ACCESSION NBR: 8208110136 DOC. DATE: 82/08/02 NOTARIZED: NO DOCKET #
 FACIL: 50-397 WPPSS Nuclear Project, Unit 2, Washington Public Power 05000397
 AUTH. NAME AUTHOR AFFILIATION
 BOUCHEY, G. D. Washington Public Power Supply System
 RECIP. NAME RECIPIENT AFFILIATION
 SCHWENCER, A. Licensing Branch 2

SUBJECT: Forwards addl info re SER outstanding Issue 10, standby svc
 water instrumentation & control design, in response to NRC
 820601 ltr. Issue 10 considered closed.

Subject: NUCLEAR PROJECT NO. 2
SAFETY EVALUATION REPORT, NUREG-0892, OUTSTANDING
ISSUE (10) STANDBY SERVICE WATER INSTRUMENTATION
AND CONTROL DESIGN, CLOSURE OF

Q. 031.139

Q. 031.139 Part 4
Sheet 2 of 4

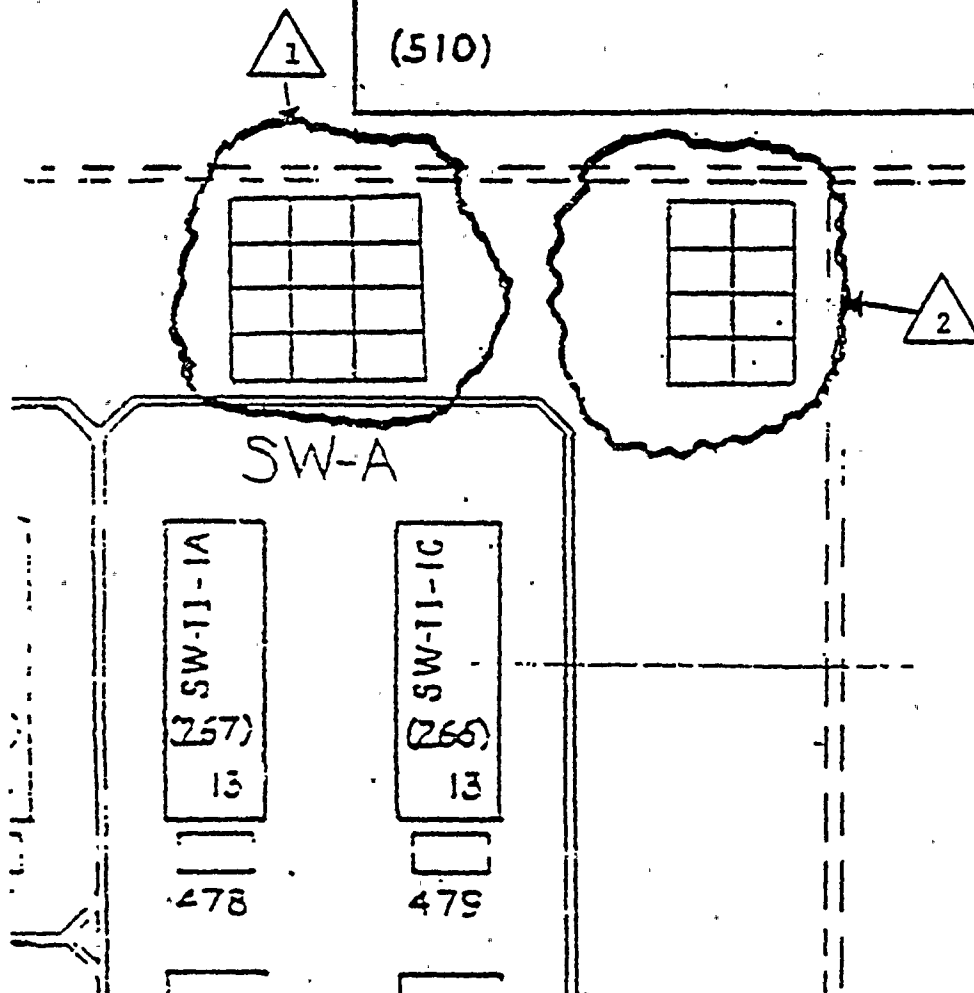
4. Confirmation that system level failures of the multiplexer system, detected by automated diagnostic techniques identified in (1) above, are indicated to the operator consistent with Regulatory Guide 1.47:

- System level failure of the multiplexer system is annunciated in the main control room in accordance with the requirement of Regulatory Guide 1.47. Division I multiplex system failure annunciation at MCR Bd, H13-P840. Division II multiplex system failure annunciation at MCR Bd, H13-P820. The system operability status is annunciated on the respective boards as illustrated in the attached diagrams.

R.G. 1.47 Display Location on HL3-P840 (Board "A")

= SW-A Bypass and Inoperable Status Indication

= CLA Div. I Bypass and Inoperable Status Indication

MULTIPLEXER CONFIGURATION

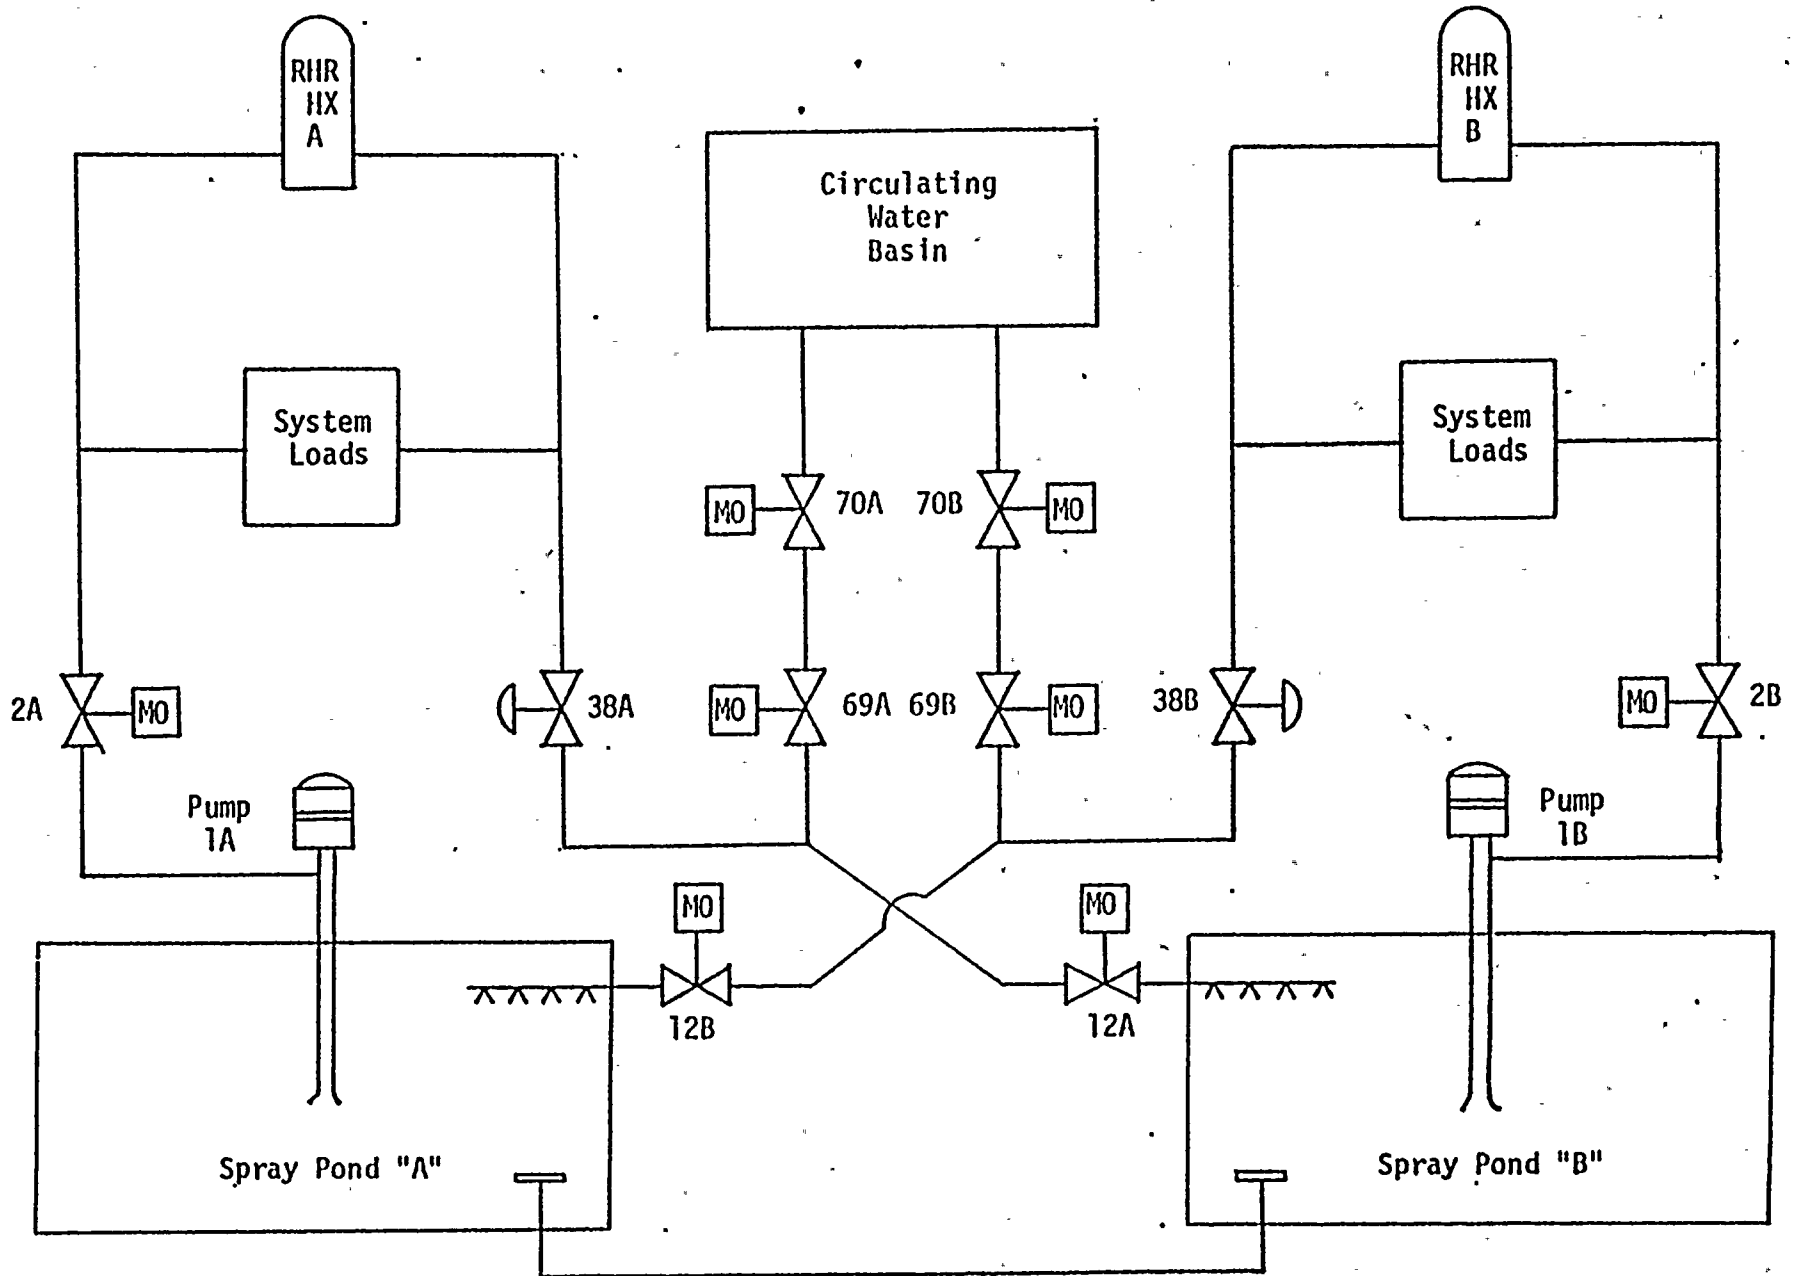
1. Copies of tables and drawings presented at the meeting:

- Attachment 1 - Summary of Meeting and Discussion
- Attachment 2 - Multiplexer Configuration
- Attachment 3 - Standby Service Water System Major Component Configuration
- Attachment 4 - Central Control Unit (CCU) Front Panel Alarm Configuration and Description

CCU FRONT PANEL

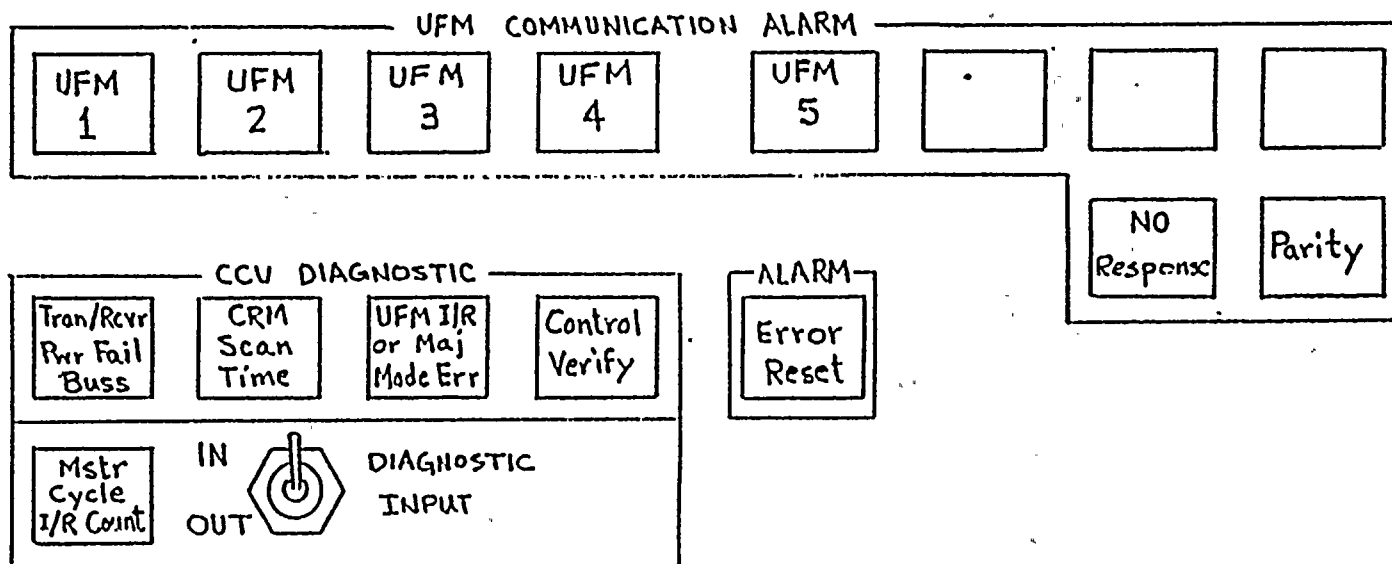
6. Describe on-line test and/or diagnostic features which may be employed including operator alarms/indicators and their position.
- Alarm display at the CCU (See Figure 1).
